RESPONSE TO NRC QUESTIONS
ON
PRESSURIZER RELIEF AND SAFETY VALVES

This report is being submitted in order to satisfy the Nuclear Regulatory Commission's Request for Additional Information (RFI) on Arkansas Power and Light Company's (AP&L) response to NUREG-0737, Items II.K.3.2, "Report on Overall Safety Effect of Power-Operated Relief Valve (PORV) Isolation System," and II.K.3.7, "Evaluation of PORV Opening Probability During Overpressure Transient." Specifically, NUREG-0737 requested the following information/justifications:

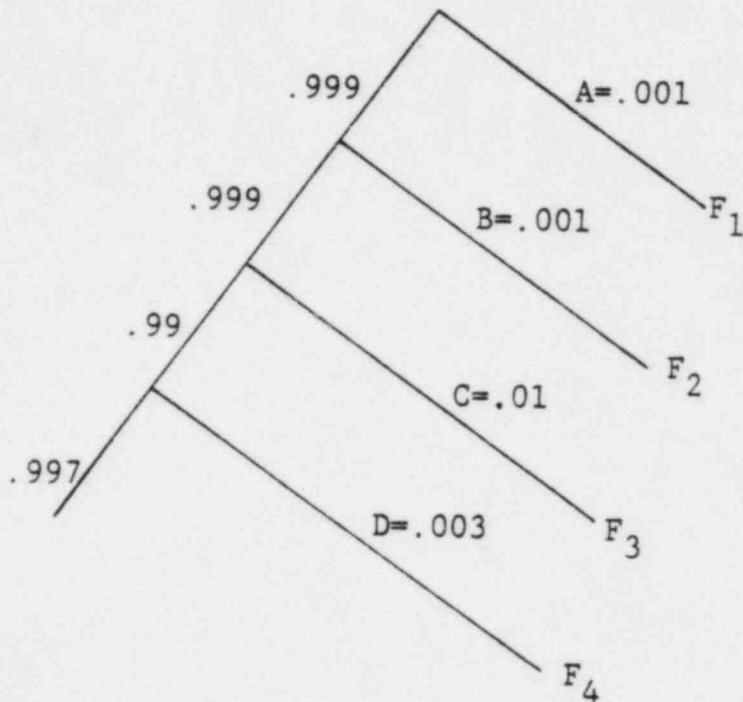
7. A justified estimate of how many PORV openings (multiple openings per transient) could be expected with each initiator frequency group.

7. This analysis generally assumed one opening per transient which results in a compact fault tree. For example, category 2 and 5 assumed one opening which is accurate for the most probable scenarios; however, less probable scenarios would have multiple lifts. In category 1 the highest frequency transient is turbine trip which produces one PORV demand. Category 3 uses different number of PORV demands based on whether offsite power is available or not. For category 4 it is assumed that the PORV cannot close therefore the number of demands is irrelevant. For the transients above that show 1 PORV lift, the value is based on operating experience. For transients where multiple lifts might occur (categories 2 and 5) the exact number of lifts cannot be accurately estimated, but a sensitivity estimate shows that even if the number of lifts were increased by a factor of 10 the probability of small break LOCA through the PORV is increased by only a factor of 2.1 percent.

ROLLOVER DATA

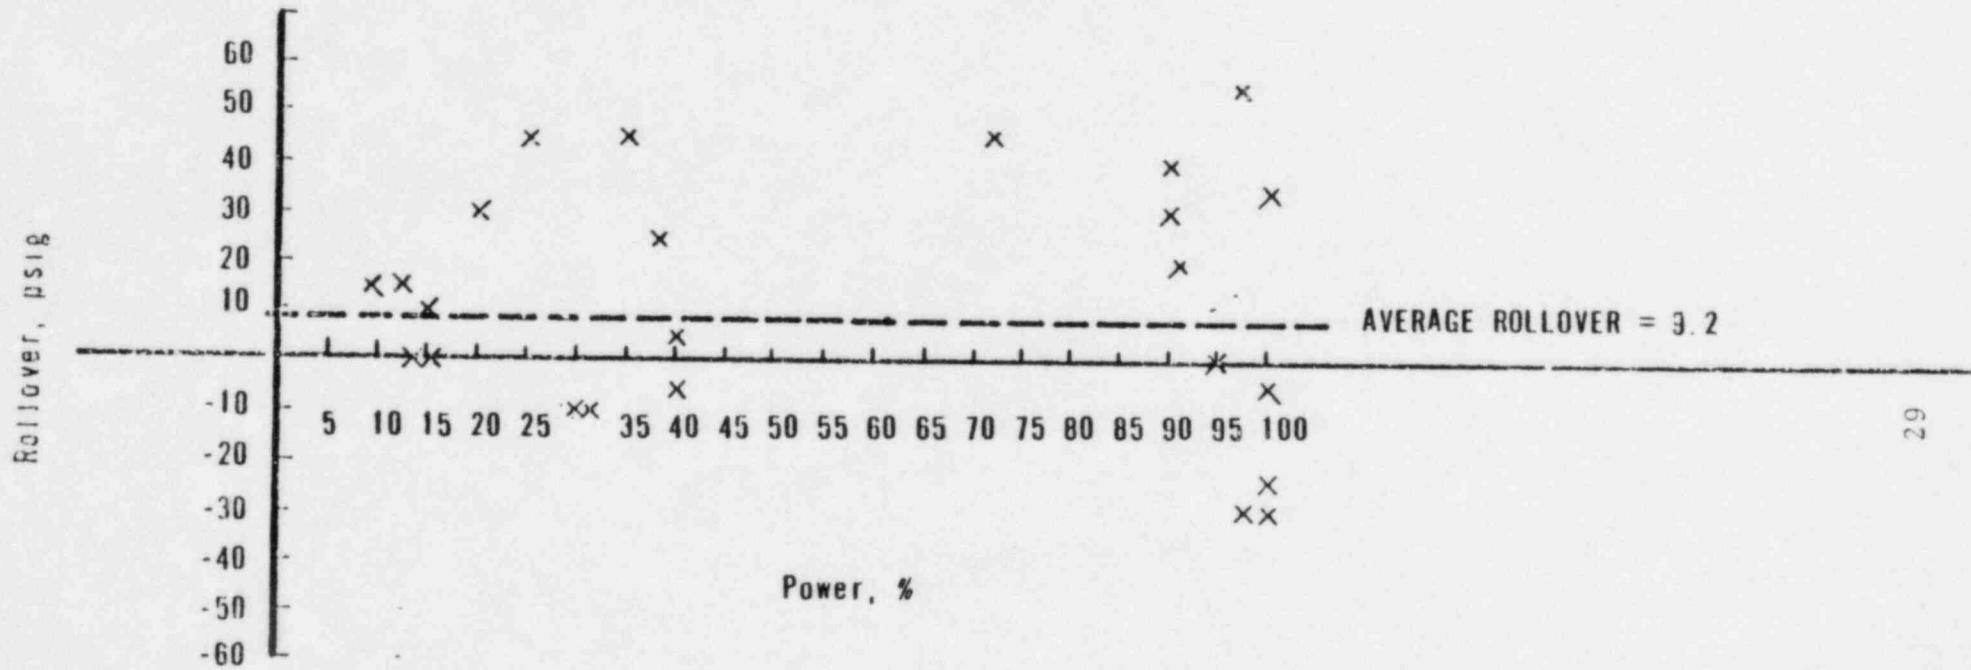
2c. A justification of the use of a constant 17.4 psi pressure correction to the rollover data and a description of the method by which the 17.4 constant was calculated.

2c. A pressure correction to the rollover data (identified by bias in the reference report) was needed to adjust the operating plant data because the setpoints are now reversed. The data obtained with pre-TMI setpoints will show a "faster" rollover because the PORV opens before reactor trip. Post-TMI setpoints will show a "slower" rollover because the PORV does not open. Since no post-TMI operating plant data was available, an adjustment had to be made. The data source was a single plant transient with the PORV block valve closed with a pressure trace available. The CADD computer code was benchmarked to this pressure transient. This resulted in a correction factor of 17.4 psi which is subtracted from the difference between PORV and RPS trip setpoints (i.e. reduces the range of difference making it more likely to actuate PORV on any given RC trip).

The mean of the rollover data has been calculated to be 9.2 psi with a standard deviation of 27.5 psi. The supporting calculations and W test* follow. The data given in Table 2.1-1 is also plotted in the attached figure. The parameters of the data were calculated with the W value of .97756 supporting the assumption of normality.
